**Amendments to the Drawings:**

Appl. No. 10/632,238  
Amendment and Response dated August 24, 2004  
Reply to Office action of May 25, 2004

FIG. 12

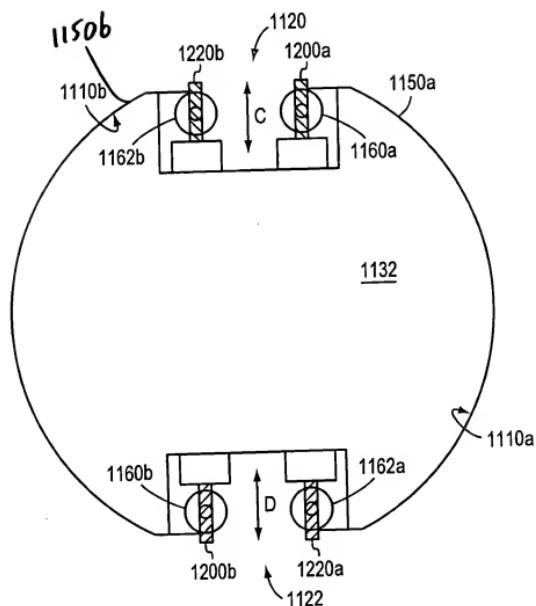
The drawings attached in the Appendix include changes to FIG. 12. Replacement sheet 11, which includes FIG. 12, replaces the original sheet 11 including FIG. 12. In FIG. 12, previously omitted element 1150b has been added.

Applicants have also amended FIG. 12 to add previously omitted reference numeral “1150b.” Support of the drawing amendment is found, for example, on page 19, paragraph 73.
